PROJECT REVIEW COMMITTEE - CITY OF WILDWOOD

Agenda

August 13, 2024 10:00 AM

SHEET 2 OF 2 PLAT BOOK _____ PAGE _____

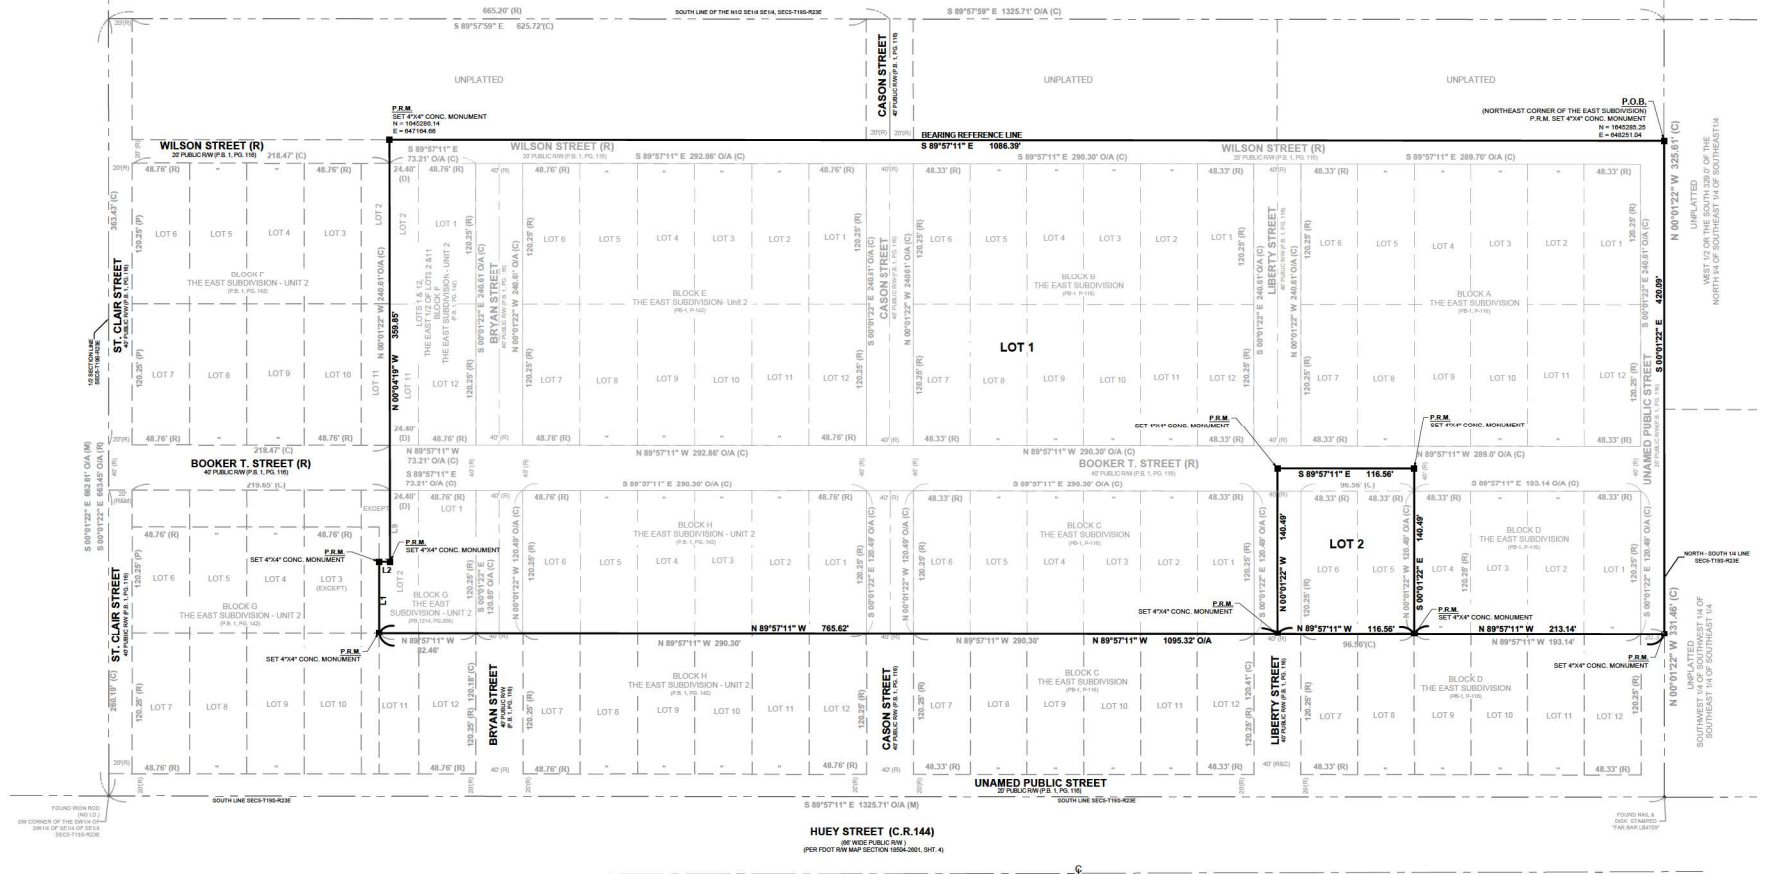
Sheet 2 of 2: At the Point of Beginning on the Plat, it says "WEAST" instead of EAST.

DRAWN BY: JDB/EL
CHECKED BY: JT
PROJECT MANAGER: JT
JOB #: 23002064
FILE CODE: ---
SHEET NO: C400

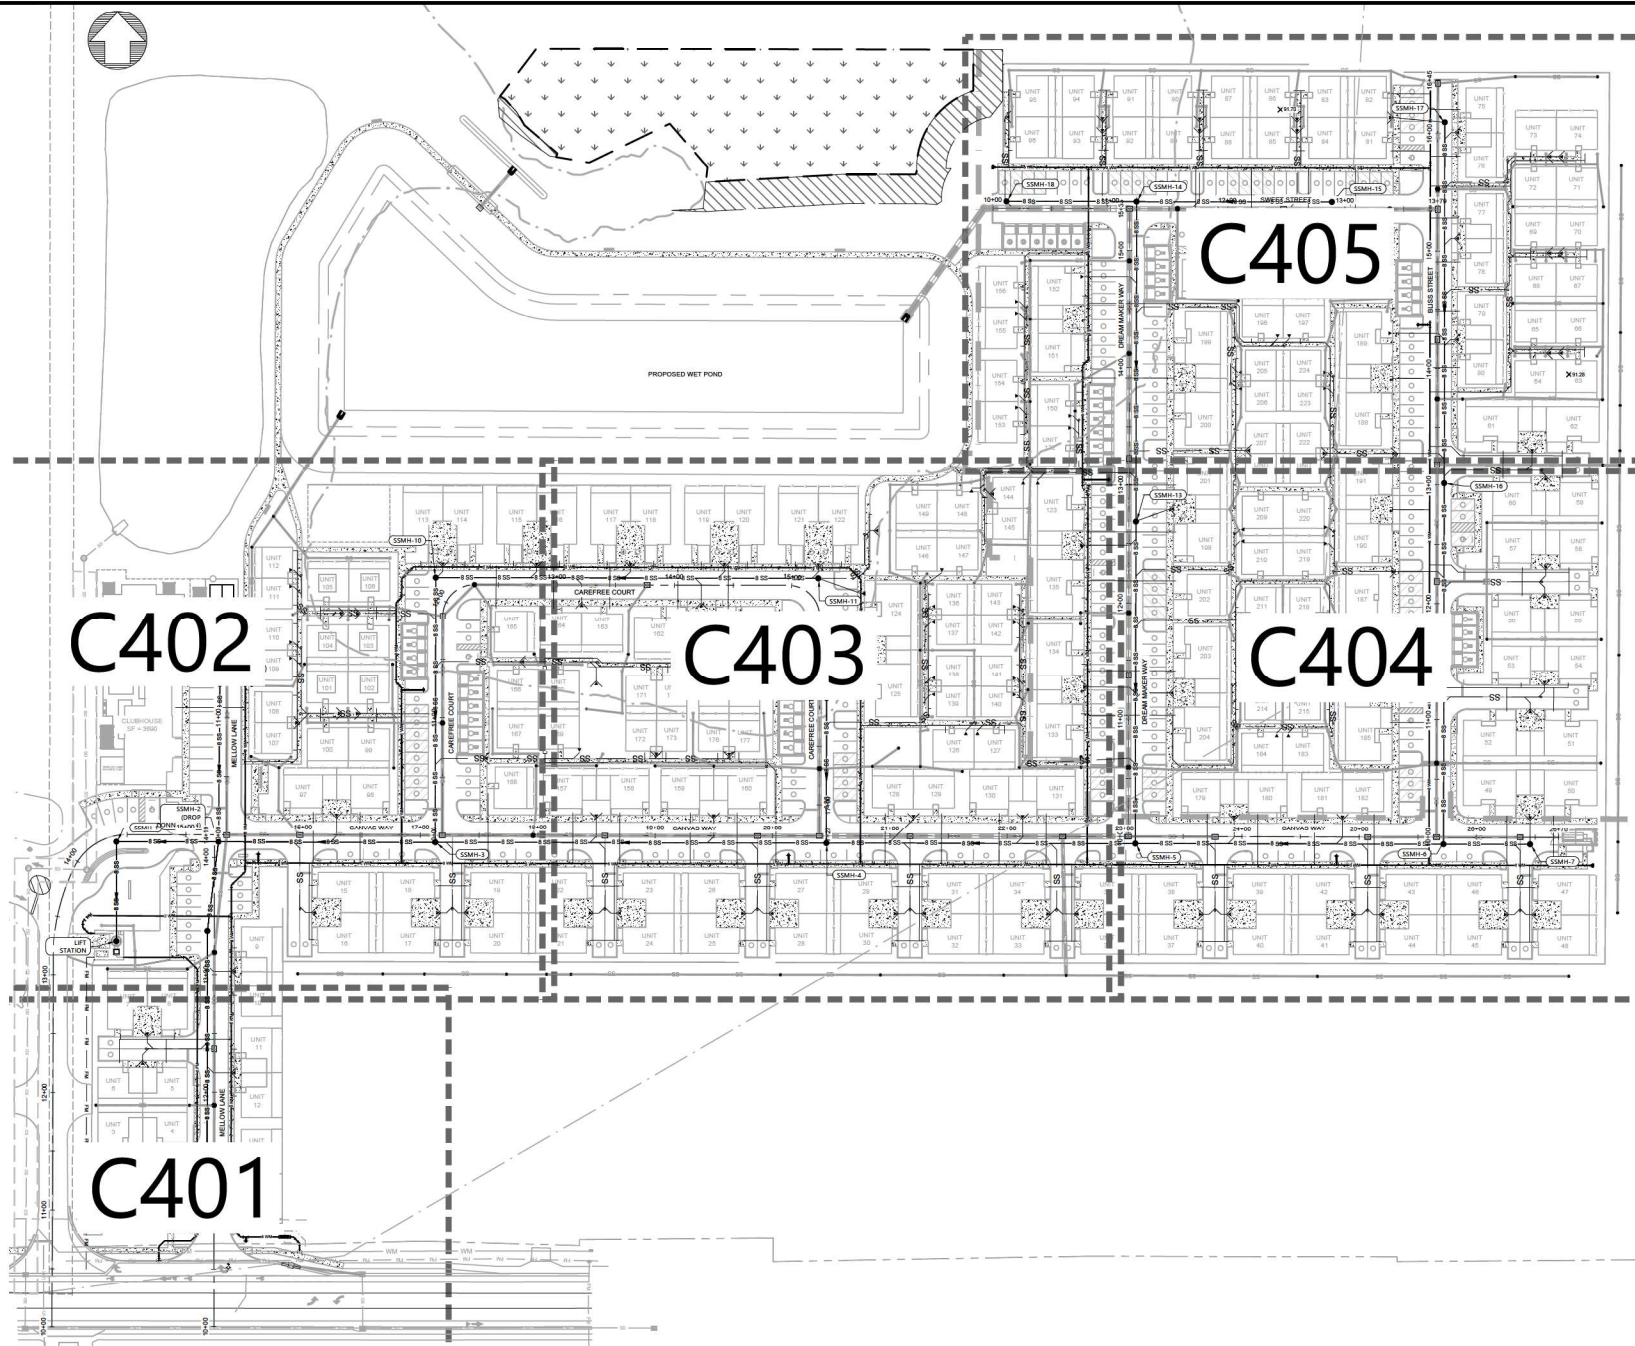
- 4. Sheet C400 – Add note to utility plan showing end of city maintenance for water and sewer connections.
 - A. Response: The note has been added.
 - I. Satisfied.

- a. **Response: The 10-foot Utility Easement was revised to end at the compound flow meter of the Compound Meter with Backflow Preventer assembly adjacent to the CR-466 ROW. Please refer to C-401 for more information.**

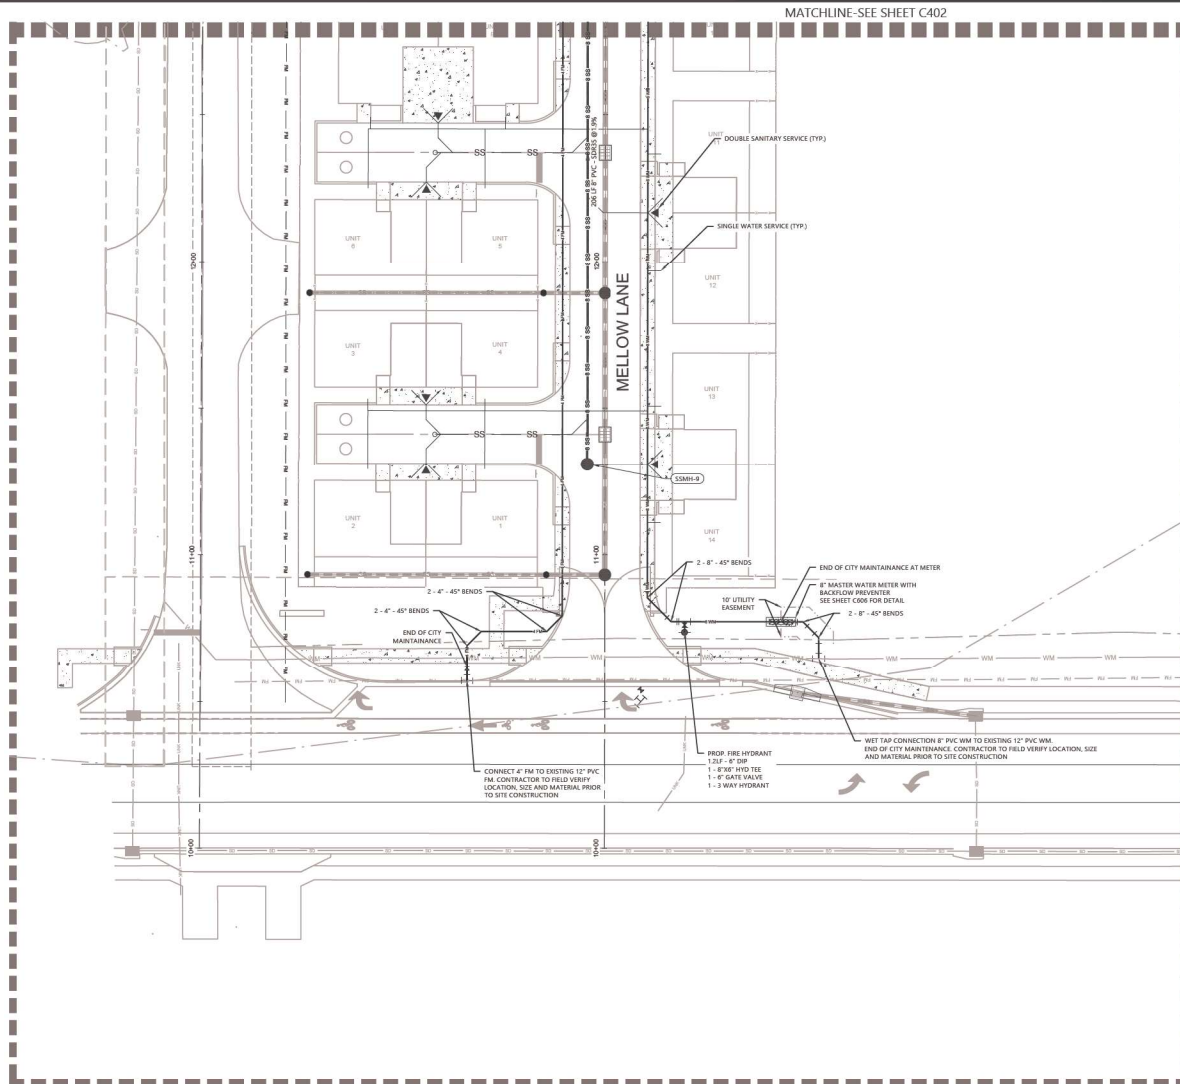
- i. **Previously satisfied.**
- 5. There is a 10-foot Utility Easement on Sheet C401. Please submit an easement application. Please see form attached.

1. Sheet C-301: Plan proposes a drainage structure over the existing force main. Relocate structure east to avoid the force main.
2. Sheet C-401: Relocate force main connection west outside of the proposed driveway.
3. Sheet C-401: Add backflow to 8" meter call out.
4. Applicant needs to acknowledge the maintenance of proposed utility mains will be extremely difficult. Plans show 8" main within 5' of residential structures.
5. All utility plan pages need to add and show sanitary sewer cleanouts for all change in directions of sanitary sewer service lines.
6. Sheet C-404: Bliss St. shows 8" water main under garage structure. Relocate the main to avoid structure.
7. Plan & Profile pages: Show horizontal separation for 8" water main and 8" sewer main on sheets 503 and 505.
